24 November 2006

Our ref: DHB/RH/05-093

**re: Concept Plan and Project Application for CSR Erskine Park Eastern Lands:-
Response to Issues Raised in Submissions**

The inclusion of the DOP land will deliver a sustainable, contiguous east-west biodiversity link between the existing north-south riparian corridors along Ropes Creek and South Creek. (See **Figure 1 overleaf**).

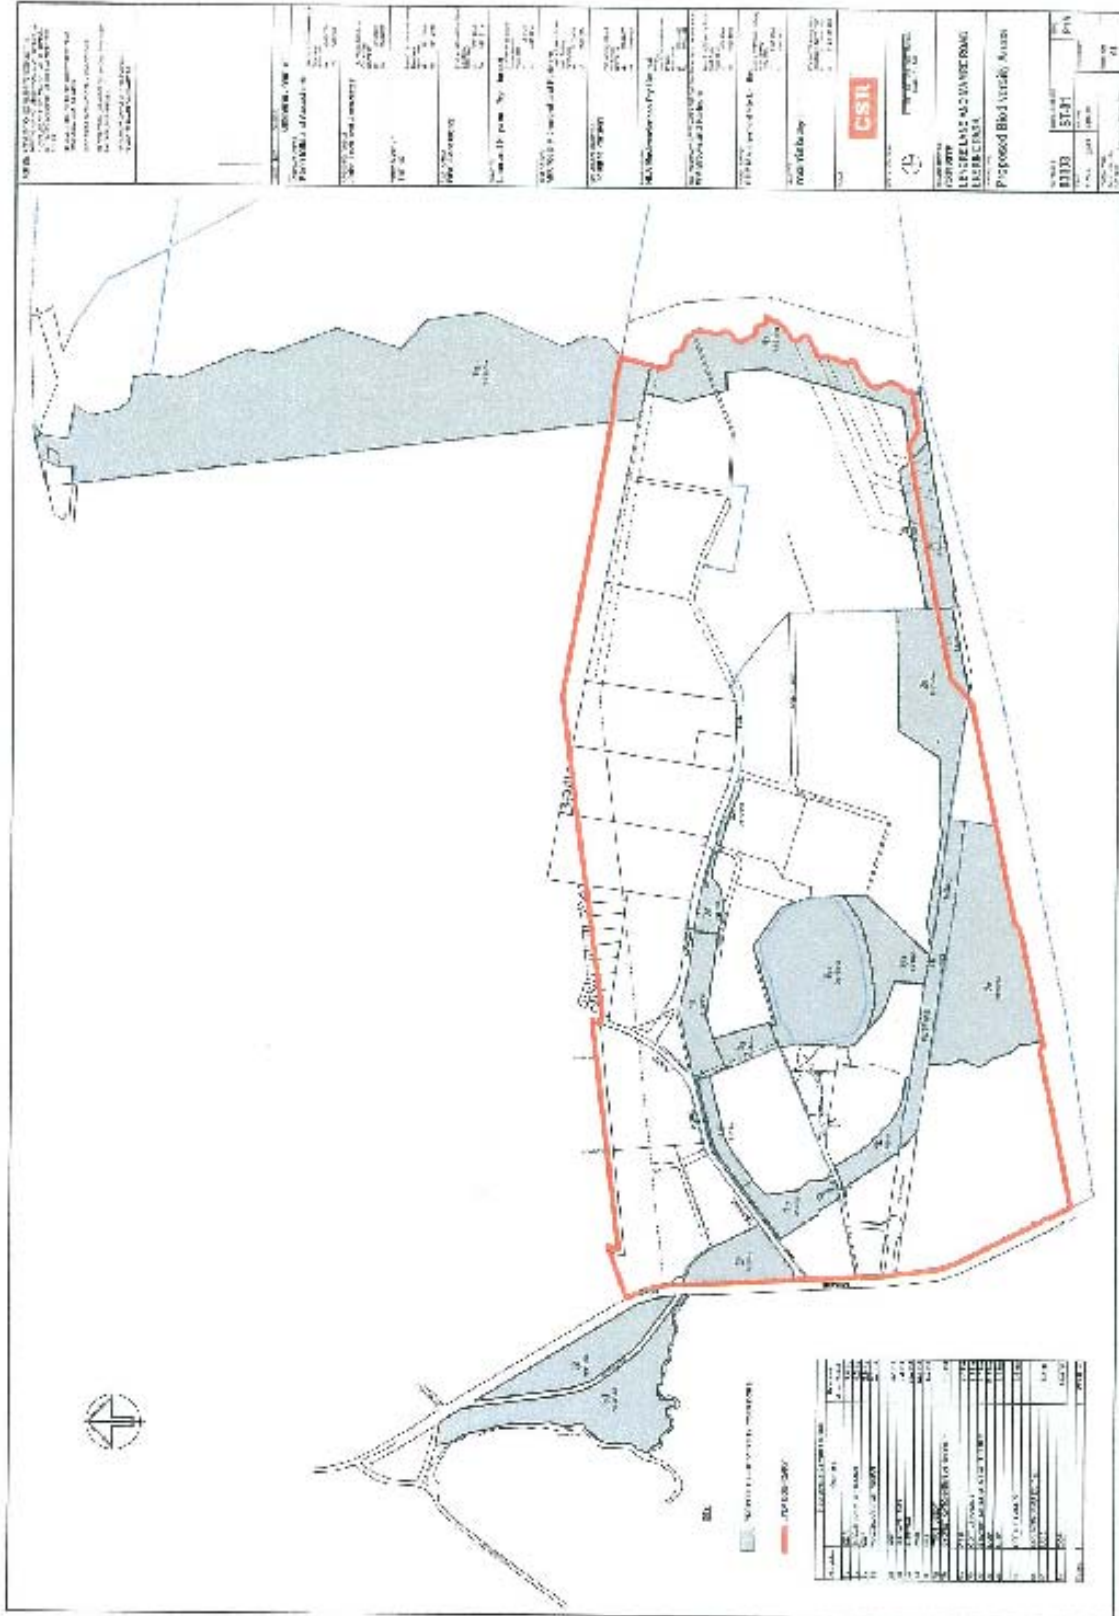
- Establishing and maintaining a Biodiversity Corridor between South Creek and Ropes Creek on approximately 85.3 hectares of land owned by the Landowners Group and 125.7 hectares of land owned by the Minister and other parties;
- Dedication of some lands within the Biodiversity Corridor owned by the Landowners Group to the Minister;
- The encumbrance of other lands within the Biodiversity Corridor with an appropriate covenant for biodiversity conservation;
- A cash payment of \$3.0m to the DOP for the establishment of the Biodiversity Corridor;
- A payment of \$1.0m to the DOP for the ongoing management and maintenance of the Corridor in perpetuity;
- A \$0.5m fee paid to DOP in recognition of the DOP's agreement to allow planting on its land adjoining the Corridor.

Map 3 – Biodiversity Management Strategy

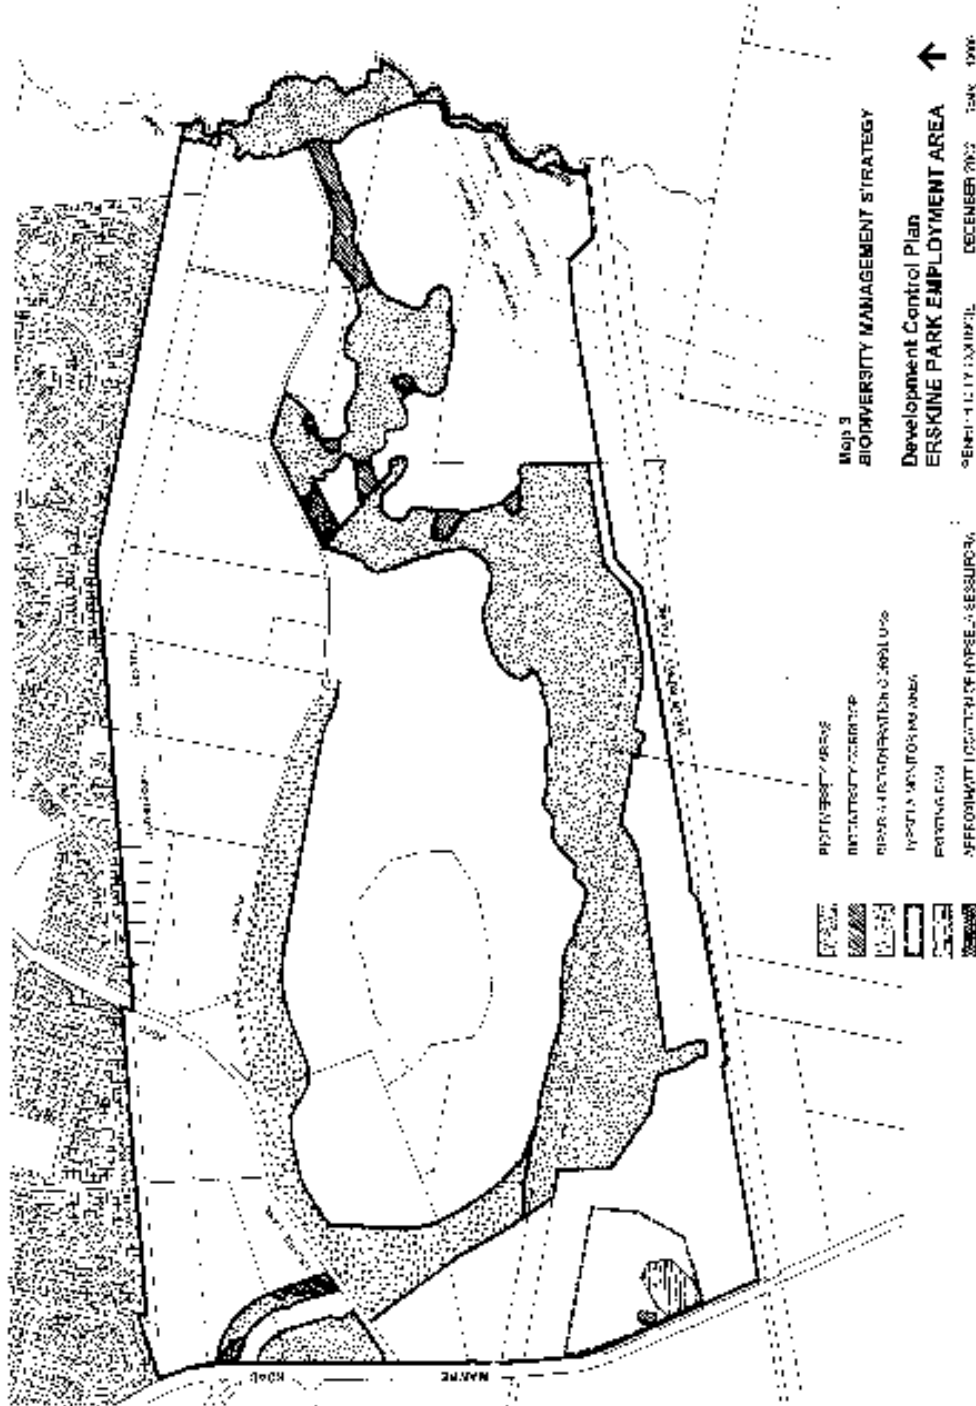
The biodiversity corridor identified in Map 3 of the DCP (**Figure 2**) contains anomalies which are recognised by both Council and the Department of Environment and Conservation.

- The *Hypsela* monitoring area needs to be removed from the plan as it is accepted by both Council and DEC that the plant doesn't occur anywhere on the site.
- DEC has identified that significant changes should be made to the nature and extent of biodiversity on the Austral land. DEC's requirement for biodiversity retention and management on the Austral land is as identified in the BMP.
- The biodiversity area identified on the Fitzpatrick land never existed when the DCP was prepared and doesn't exist now. The BMP proposes to add biodiversity to the Fitzpatrick land as identified in the BMP.
